ADDENDUM NO. 3

PROJECT NAME: **Fredericksburg Road Congestion Mitigation**

DATE: March 30, 2011

CIMS PROJECT NO.: **40-00016**

FREDERICKSBURG ROAD BOND PROJECT
4" PVC MULTIDUCT CONDUIT
[2-WAY SYSTEM]

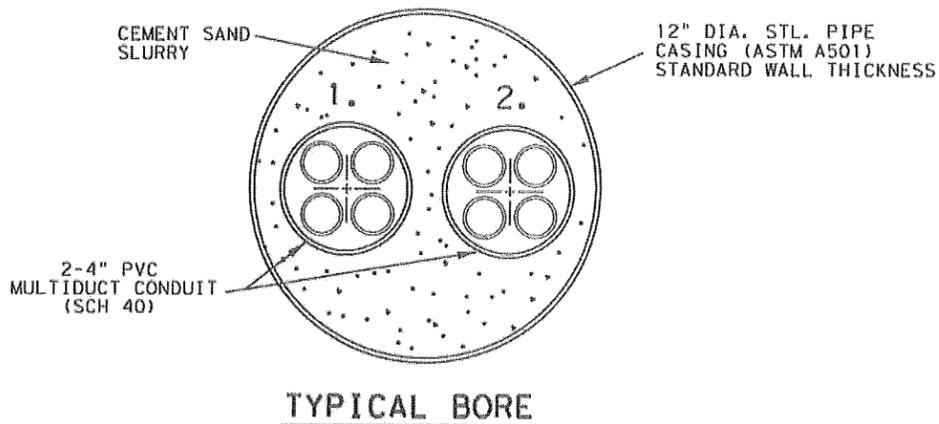
A5. Sheet 229 of 234 shows the standard depth of flowable fill when not under pavement. There is a note with an asterisk that shows the depth of flowable fill when used under the pavement. An asterisk has been added to the Modified Trench Detail on that sheet (attached).

* CONTRACTOR SHALL CONCRETE ENCASE FULL DEPTH (WITH FLOWABLE BACKFILL) ANY TRENCHES THROUGH MAINLANES, SHOULDERS, FRONTAGE ROADS, INTERSECTIONS, OR RAMPS. TOP OF CONCRETE SHALL BE 2" BELOW FINISHED GRADE OR AS DIRECTED BY THE ENGINEER. 2" OF ASPHALT SHALL BE PLACED ON TOP OF CONCRETE ENCASEMENT TO FINISHED GRADE. ANY ADDITIONAL CONCRETE SHALL NOT BE PAID FOR DIRECTLY BUT SHALL BE CONSIDERED SUBSIDIARY TO THE VARIOUS BID ITEMS.
